Minute No. 623
Report - Standing Policy Committee on Property and Development - July 18, 2005

Item No. 5 Amendment to the Approval of DASZ 12/2003 (Paul Martin Drive)
File DASZ 12/2003

Re: Proposed amendment to the approval of DASZ 12/03 (Paul Martin Drive) – DASZ 12/03

A copy of a sketch forming part of Council's July 21, 2004 approval is attached.

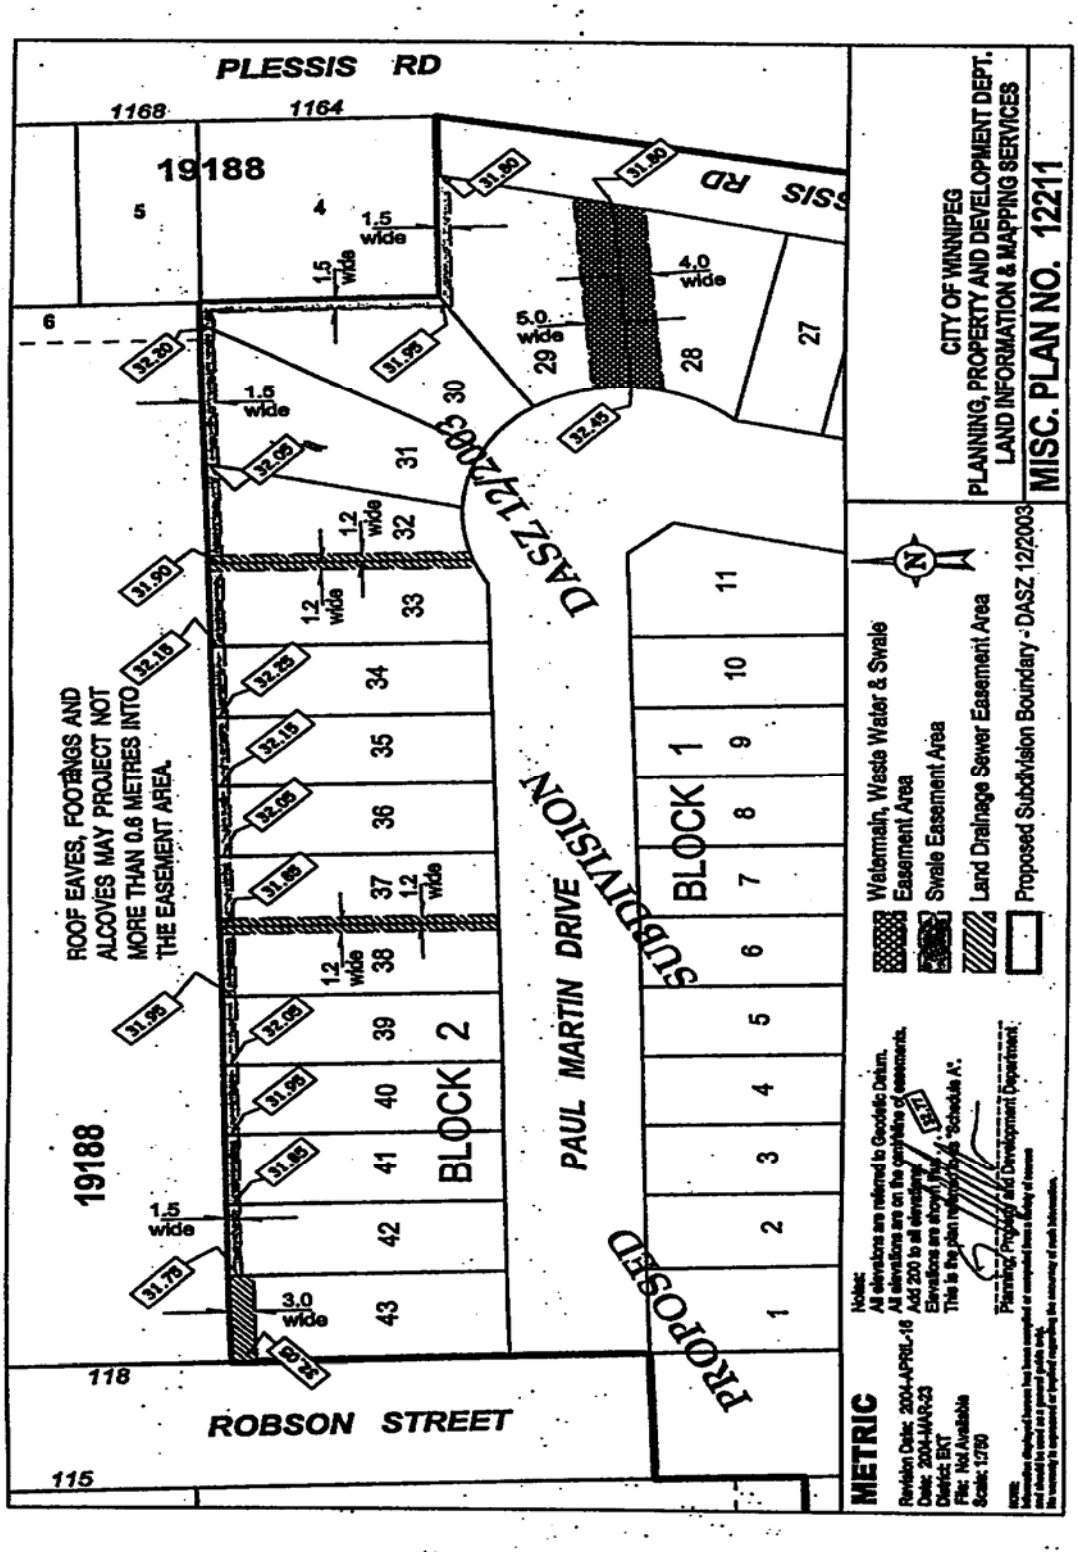
Due to an oversight by the Developer's real estate agent, Lot 29, Block 2 was sold with no provision for the agreement between the City and the Developer that a pedestrian walkway and emergency access would be established on the most southerly 5.0m of Lot 29. The balance of the walkway/access to be established across Lot 28, Block 2 is still available. The Developer, following months of negotiations with the owner of Lot 29, Block 2, was able to purchase 2.0m which would be transferred to the City resulting in a 6.0m walkway rather than the 9.0m walkway initially contemplated. The Public Works Department has assessed the situation and has determined that the 6.0m walkway could also accommodate an emergency vehicular access as this width is comparable to the width of a standard lane right-of-way.

It is therefore recommended that Council's approval of July 21, 2004 be amended by stipulating that the Developer shall transfer 6.0m to the City for the establishment of a walkway and emergency access rather than 9.0m. (All other conditions of Council's July 21, 2004 approval remain unchanged.)
